Docket Number:	79-AFC-01C
Project Title:	Compliance - Application for Certification for PG&E Geysers Unit 17 (78-NOI-3)
TN #:	214573
Document Title:	Notice of Determination - Petition to Amend the Final Decision for the Lakeview Geothermal Project
Description:	*** THIS DOCUMENT SUPERSEDES TN 214572 *** Notice of Determination for the Lakeview Geothermal Project
Filer:	Bruce Boyer
Organization:	California Energy Commission
Submitter Role:	Commission Staff
Submission Date:	11/29/2016 8:24:13 AM
Docketed Date:	11/29/2016

NOTICE OF DETERMINATION

PETITION TO AMEND THE FINAL DECISION FOR THE LAKEVIEW GEOTHERMAL PROJECT (79-AFC-01C)

ENVIRONMENTAL JUSTICE POPULATION FIGURE

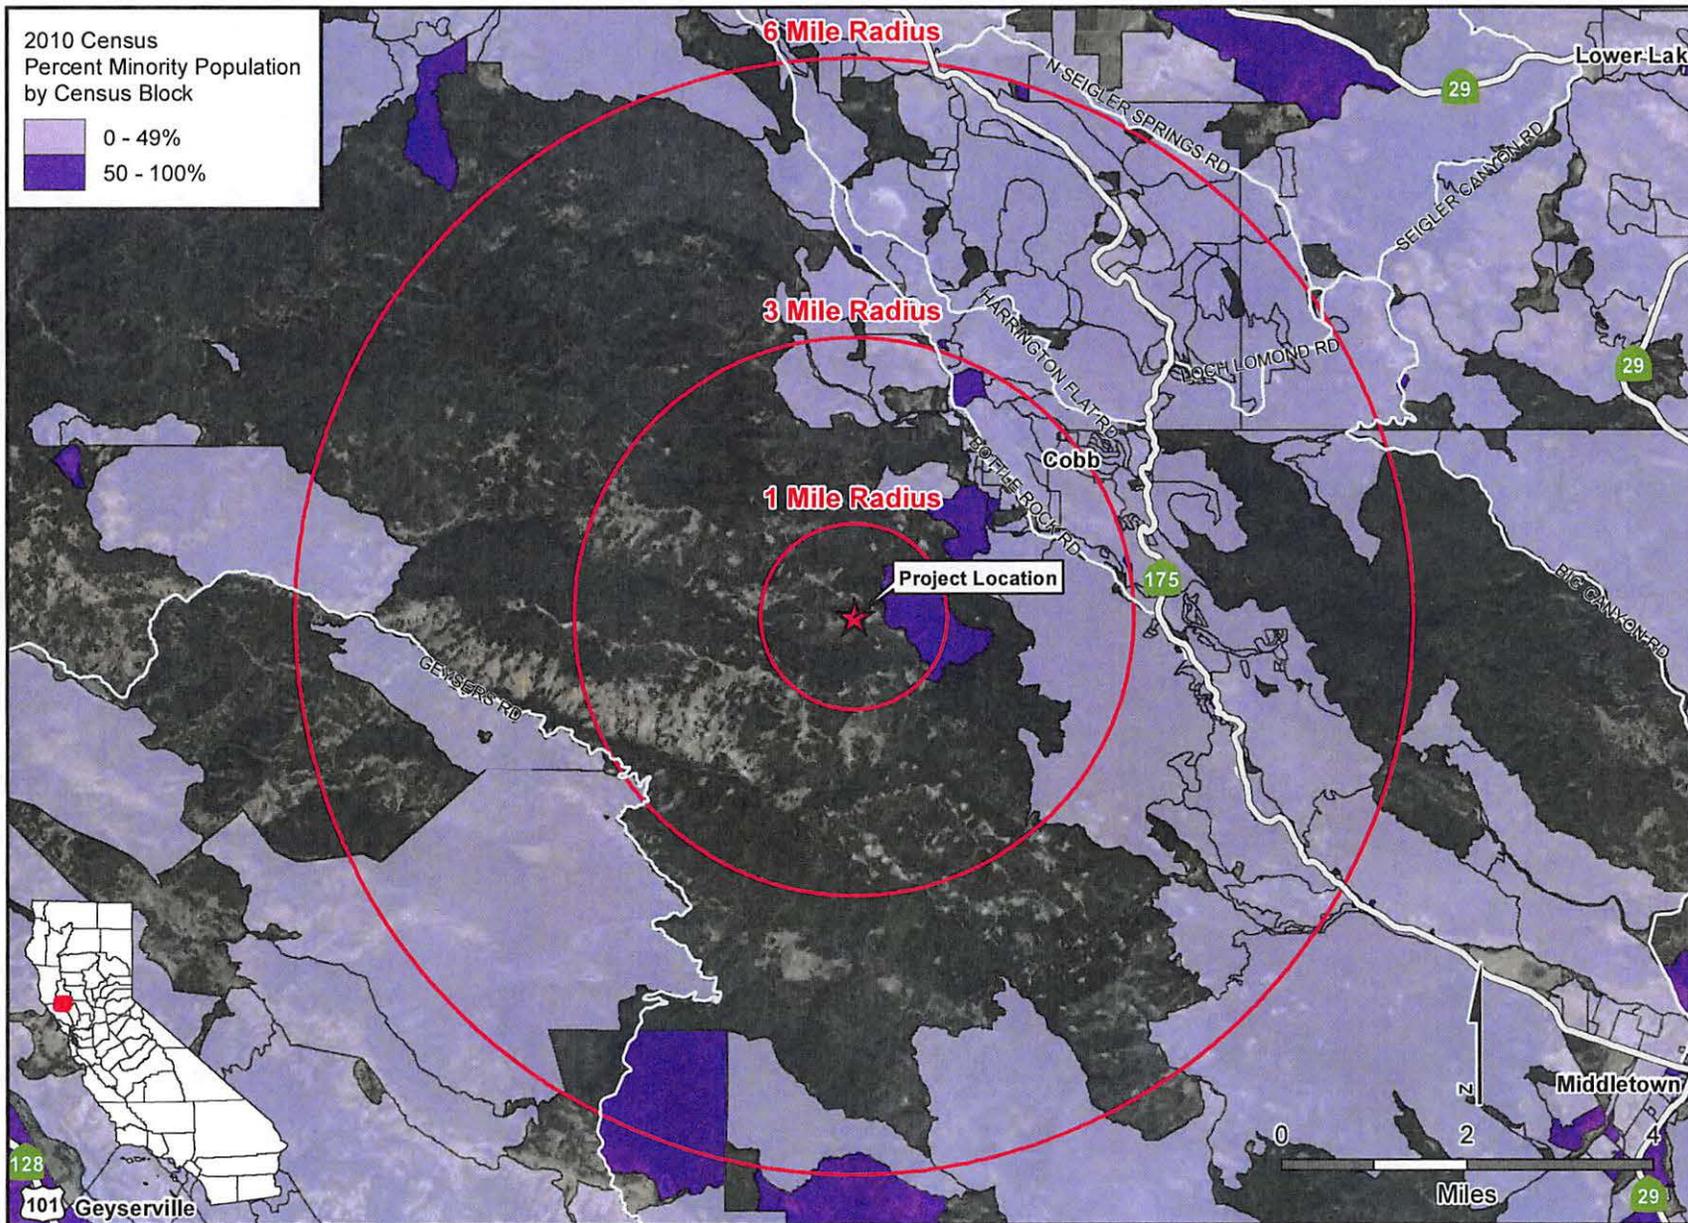
The **Environmental Justice (EJ) Population Figure** shows 2010 census blocks in the six-mile radius of Unit 17 with a minority population greater than or equal to 50 percent. The population in these census blocks represents an EJ population based on race and ethnicity as defined in the Council on Environmental Quality's *Environmental Justice: Guidance Under the National Environmental Policy Act*.
